**DAC 25/07/23 – 21 PARNELL PLACE NEWCASTLE EAST –
DA2022/00705 – MIXED USE - ALTERATIONS AND ADDITIONS TO
EXISTING HOTEL OR MOTEL ACCOMMODATION (NEWCASTLE
BEACH HOTEL), ANCILLARY FOOD AND DRINK PREMISES AND
COMMERCIAL USE (ANCILLARY HOTEL SPA) AND DUAL
OCCUPANCY (ATTACHED 2 X DWELLINGS)**

PARNELL PLACE

21 Parnell Place, Newcastle East, NSW 2300
LOT 1 /DP815595

DRAWING
 SHADOW DIAGRAMS -
 SHEET 3

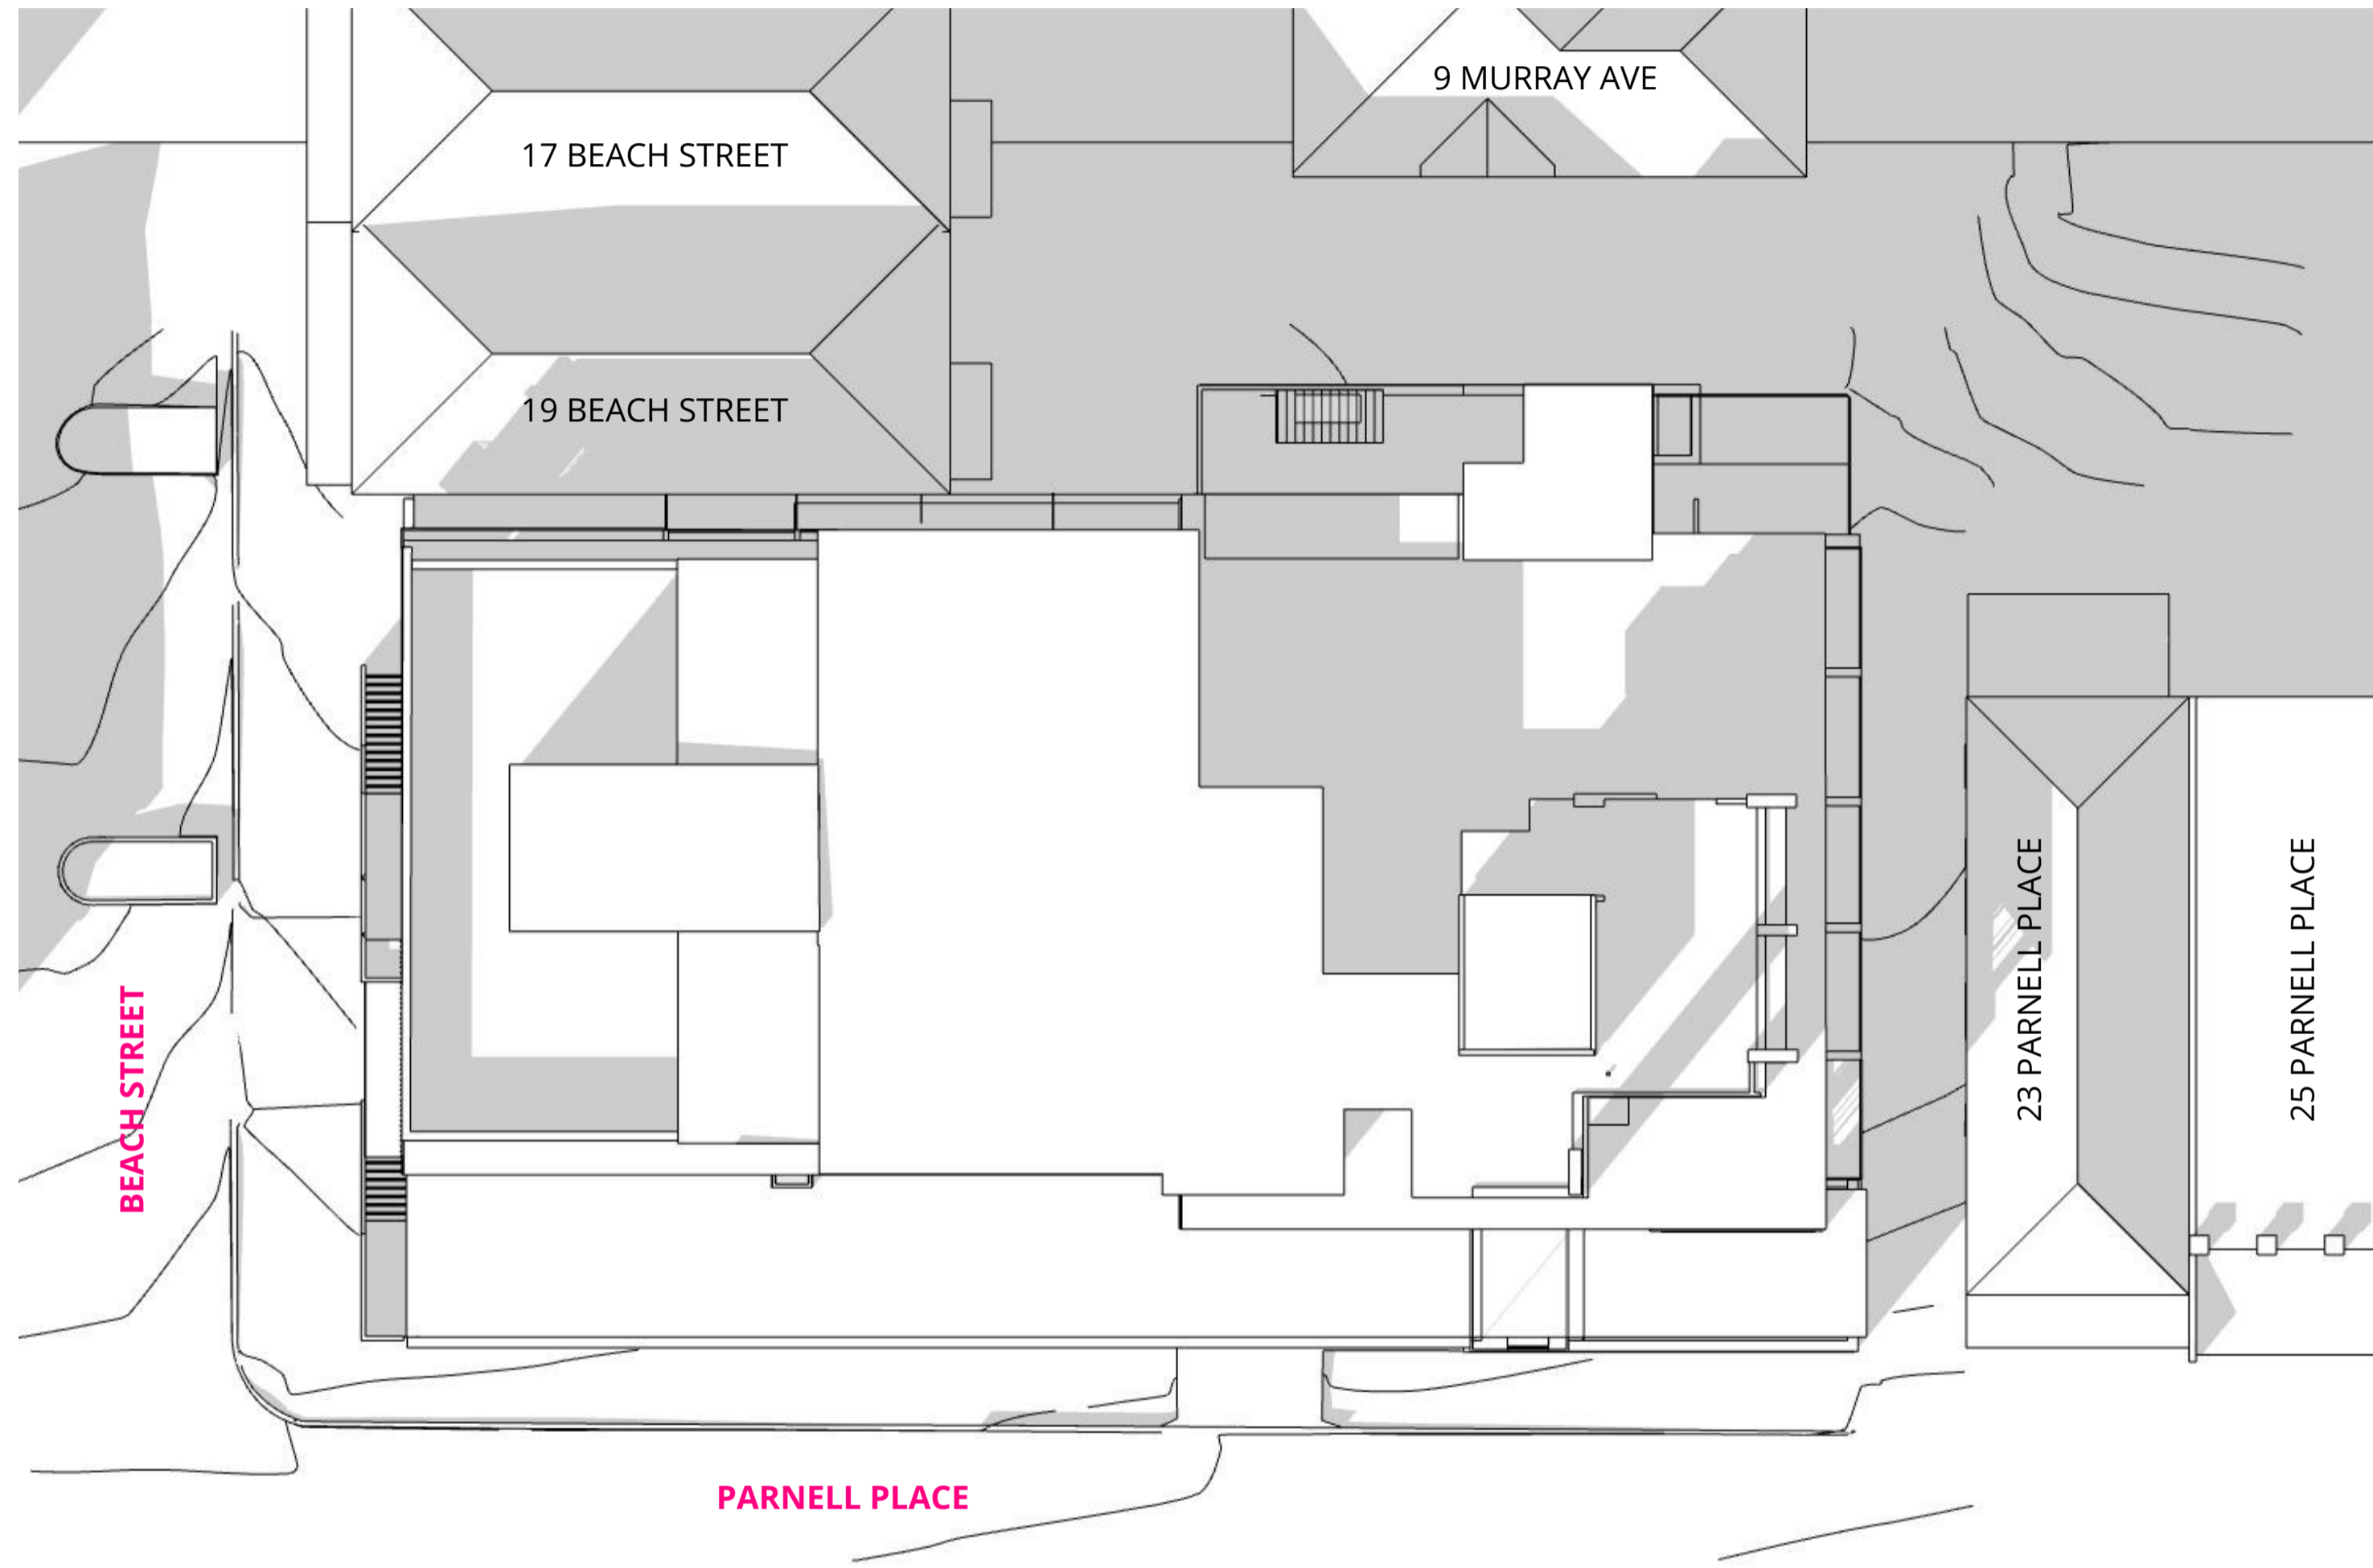
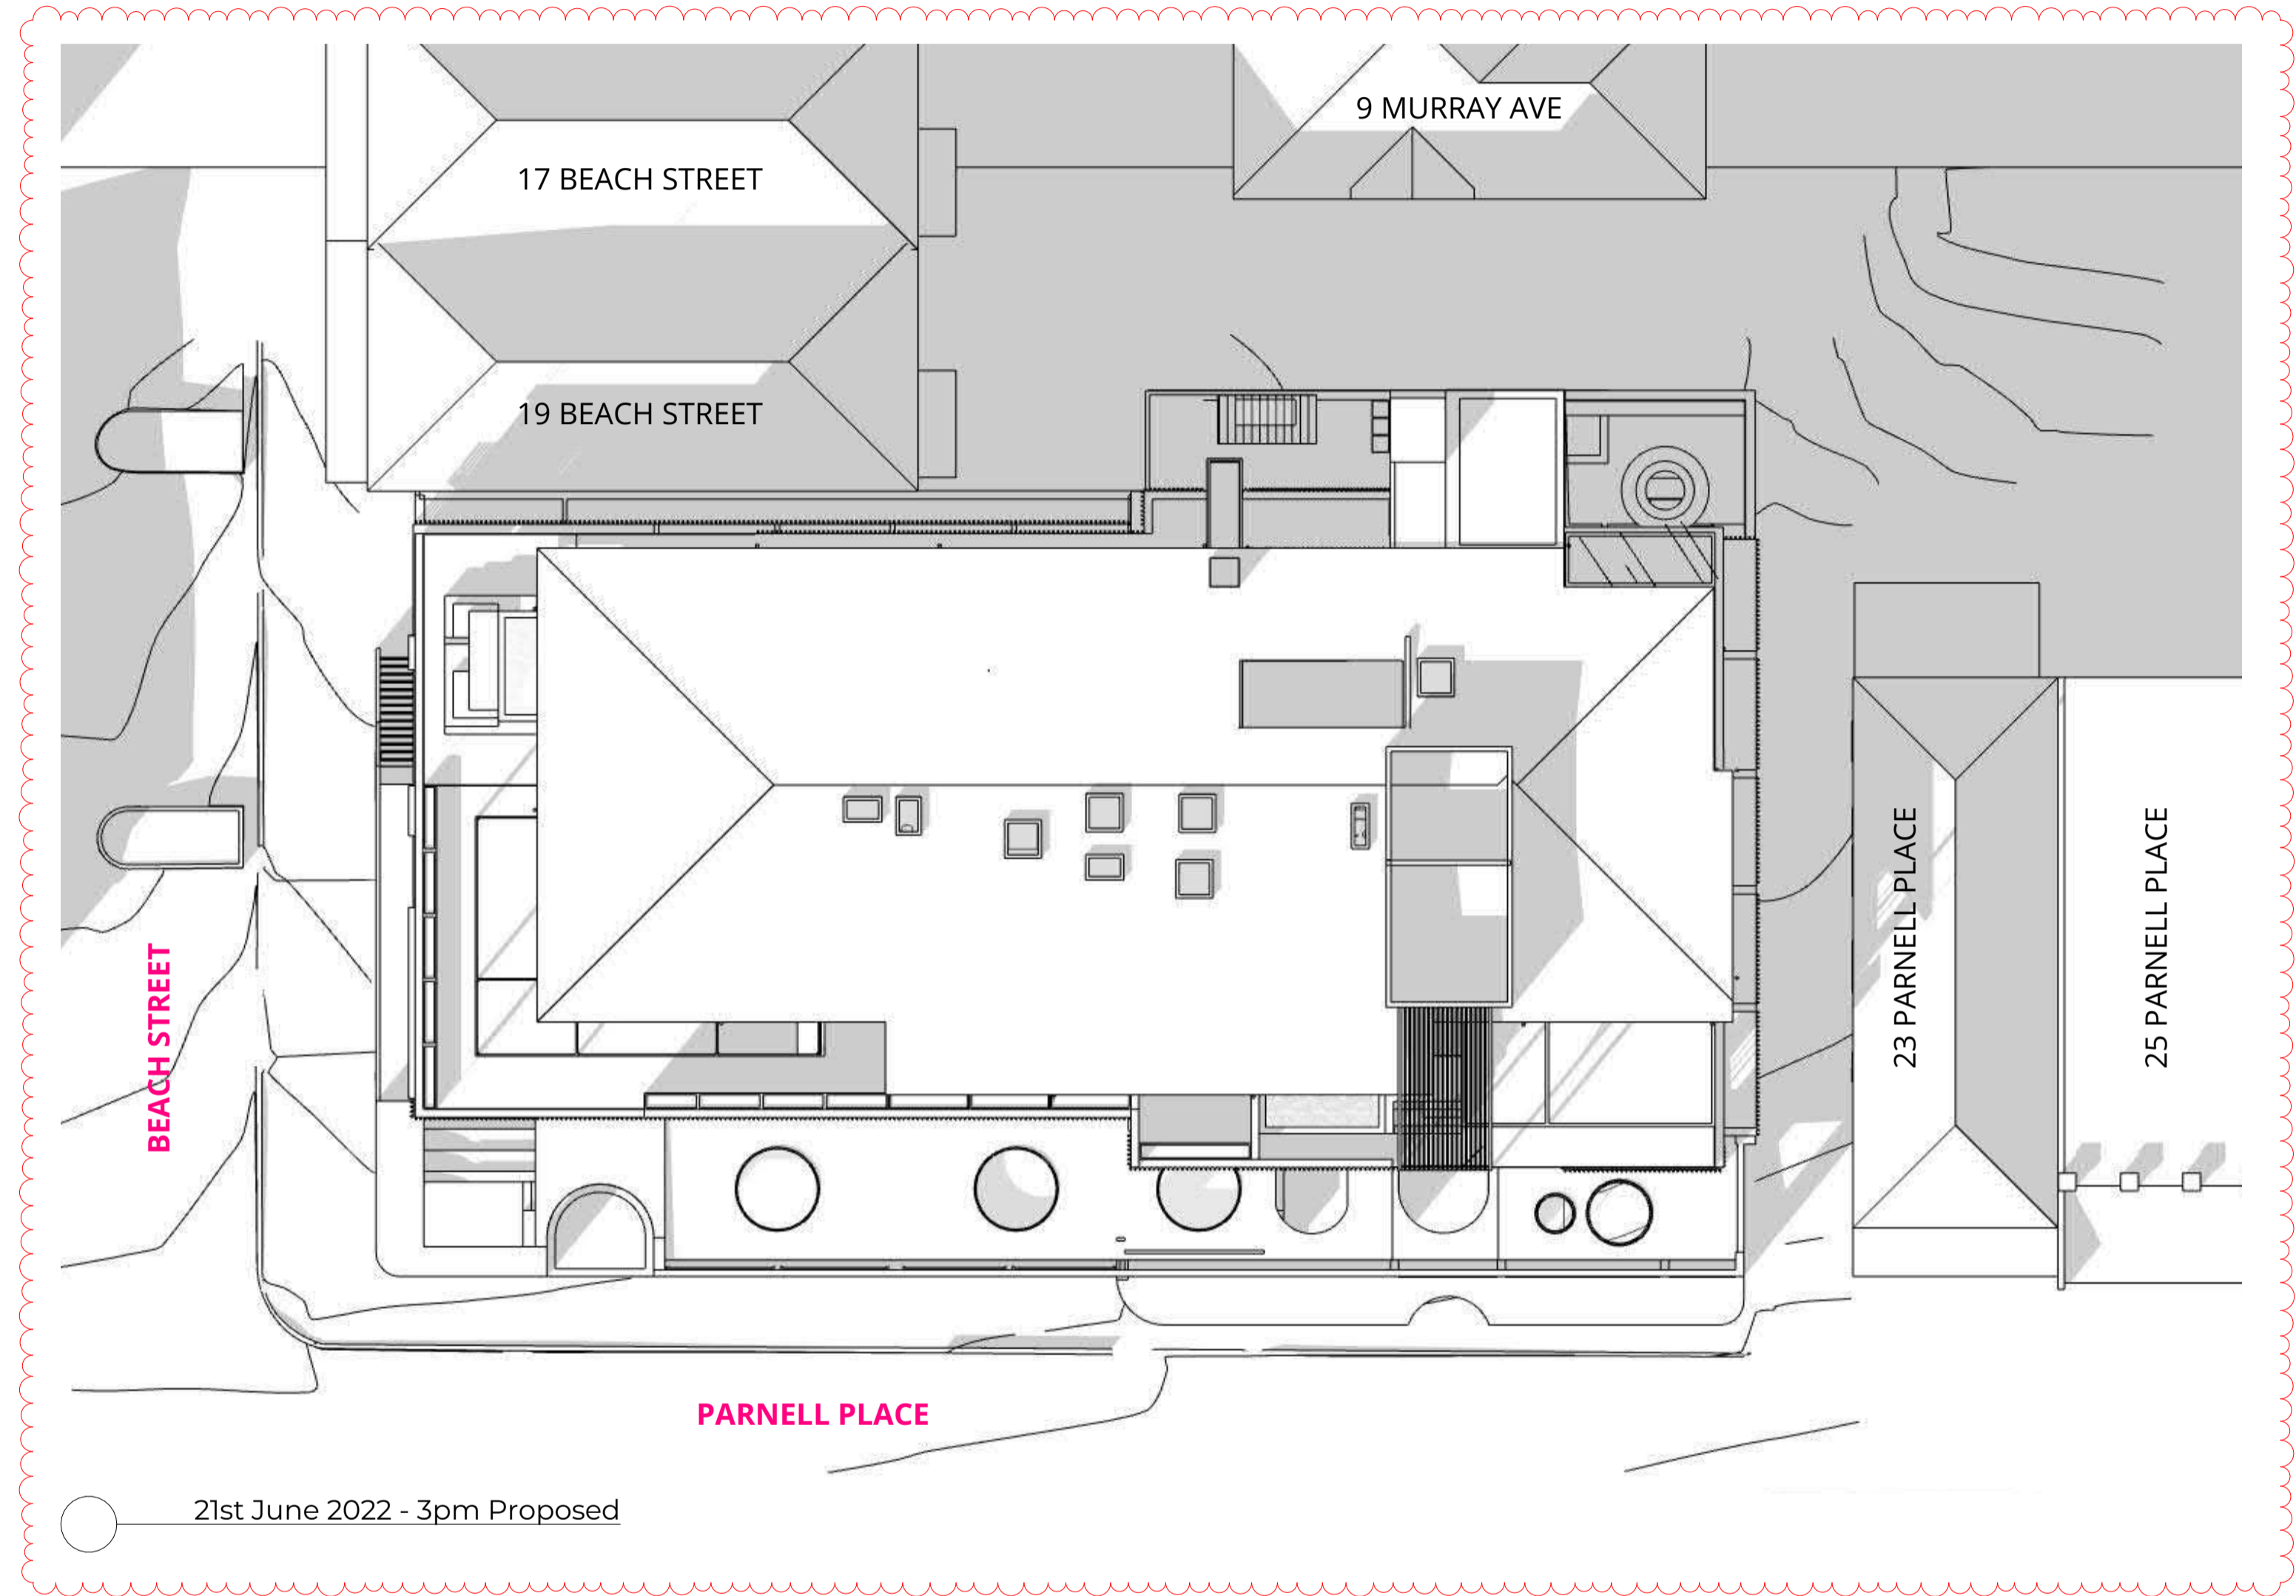
- PENTHOUSE 2 SETBACK FROM SOUTH EAST CORNER BY 1200MM AND LOW GARDEN ADDED TO SOFTEN EDGE AND REDUCE BULK & SCALE
- PENTHOUSE 2 MOVED 600MM TO WEST TO MAINTAIN FLOOR AREA
- PENTHOUSE 2 EAVE REDUCED BY 600MM TO REDUCE SCALE
- PENTHOUSE MOVED 600MM TO WEST TO MAINTAIN FLOOR AREA
- ADDITIONAL LANDSCAPING TO PENTHOUSE 01 NORTH-WEST CORNER
